**Comments of the
American Automobile Manufacturers Association
on the California Air Resources Board (CARB)
Notice of Public Hearing
to Consider Technical Status and Proposed Revisions
to Malfunction and Diagnostic System Requirements
for 1994 Model-Year Passenger Cars, Light-Duty Trucks,
and Medium Duty Vehicles and Engines (OBD II)**

**GENERAL MOTORS STATEMENT TO THE
CALIFORNIA AIR RESOURCES BOARD (CARB)
REGARDING PROPOSED REVISIONS TO THE
ON-BOARD DIAGNOSTIC REQUIREMENTS (OBD-II)**

NOTICE OF PUBLIC HEARING TO CONSIDER)
 TECHNICAL STATUS AND PROPOSED REVISIONS)
 TO MALFUNCTION AND DIAGNOSTIC SYSTEM) Mail Out
 REQUIREMENTS FOR 1994 MODEL-YEAR) #94-38
 PASSENGER CARS, LIGHT-DUTY TRUCKS)
 AND MEDIUM DUTY VEHICLES AND ENGINES (OBD II))

Figure 1

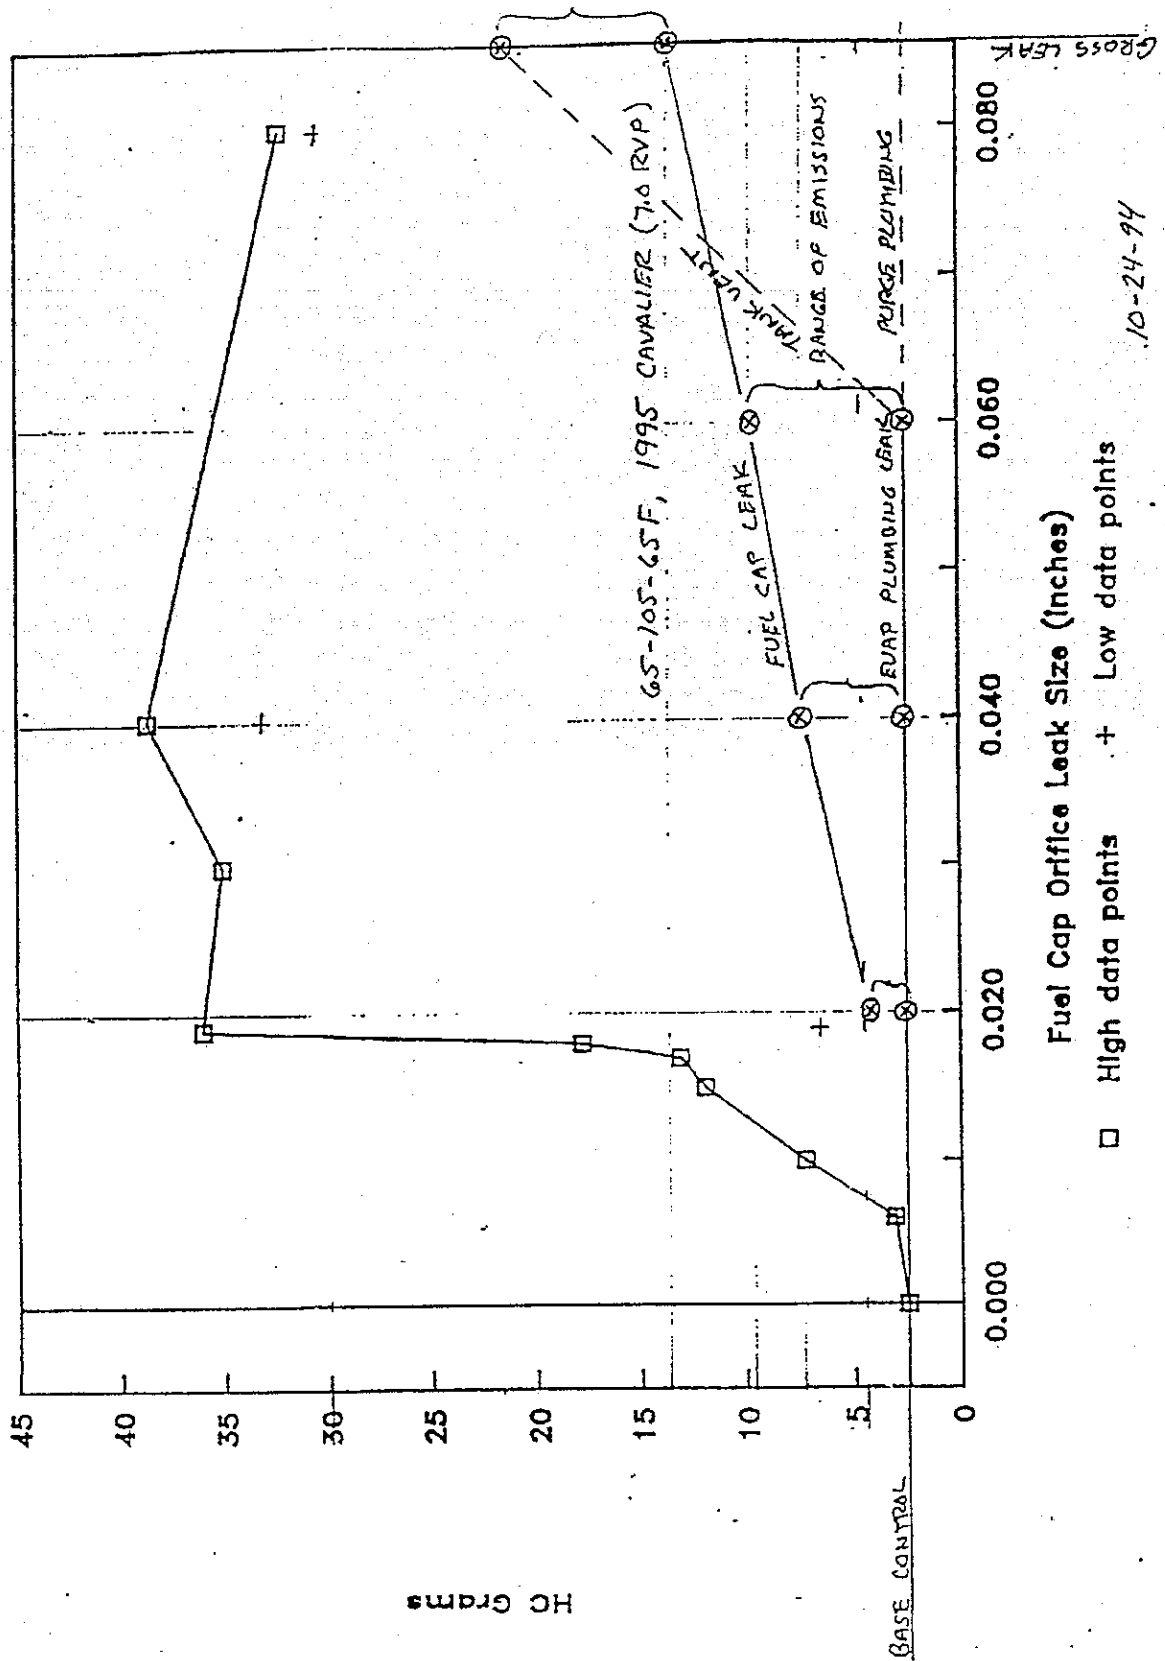
Evaporative System Monitoring: The staff has proposed to revise section (b)(4.0) to require detection of 0.020 inch leaks beginning with the 1998 model year with a phase-in of 50/75/100 percent of evaporative families. The justification for the increase in stringency was that there could be significant further emission reductions by reducing the size of leak to be detected. This emissions reduction conclusion is based, in part, upon data generated by GM using a 1990 Buick Regal.

GM believes that the staff is overestimating the significance of the contribution of small leaks (between 0.020 and 0.040 inch) to in-use emissions for many reasons. The data from the CARB surveillance programs, which the staff used as evidence that 0.020 inch leaks occur frequently in-use, was not collected under sufficiently controlled conditions to give accurate results. (While the CARB staff recently investigated the effects of fuel cool down, their study did not reflect the high temperatures reached at the tops of metal fuel tanks because of exhaust system heating, etc., and the subsequent effect of rapid cool down on the pressure of the vapor space.) Furthermore, no attempt was made to find small leaks and determine the area of the leak opening in the surveillance programs. Since the pressure data are suspect and no small leaks were actually identified, the staff has not demonstrated that leaks between 0.020 and 0.040 inch exist in significant numbers in the field. After analyzing the in-use data which has been collected by CARB, EPA, and GM, we have concluded that the percent of in-use vehicles with leaks between 0.020 and 0.040 inch is much lower than the CARB staff's estimate of 7.8 percent.

More importantly, radically improved designs needed to meet both the enhanced evaporative and Federal On-board Refueling Vapor Recovery requirements have reduced the resistance of vapor flowing to the canister which has dramatically reduced the potential emissions resulting from small leaks. The previous data we submitted for a 1990 vehicle are no longer applicable. As illustrated in Figure 1, the emissions from a 0.020 inch leak on a 1995 Cavalier with 7.0 RVP fuel are expected to range from negligible to 3 grams HC depending on leak location. Average emissions from 0.020 inch leaks would be much less than 3 grams HC. This is a dramatic reduction from what was observed on a 1990 vehicle. Recent data generated by another manufacturer supports this trend, showing emissions from a 0.020 inch leak that are less than 0.2 grams HC.

The CARB should delay requiring a 0.020 inch threshold until it is demonstrated to be cost effective and until it has been demonstrated that it is feasible to find and repair leaks smaller than 0.020 inch. If this can be demonstrated, the 0.020 inch threshold should be phased-in, starting no sooner than the 2001 model year, to allow sufficient lead time for new diagnostic systems/hardware. If the CARB elects not to delay the phase-in, GM would prefer that the phase-in be modified to coincide with the phase-in of the Federal on-board refueling vapor recovery requirements.
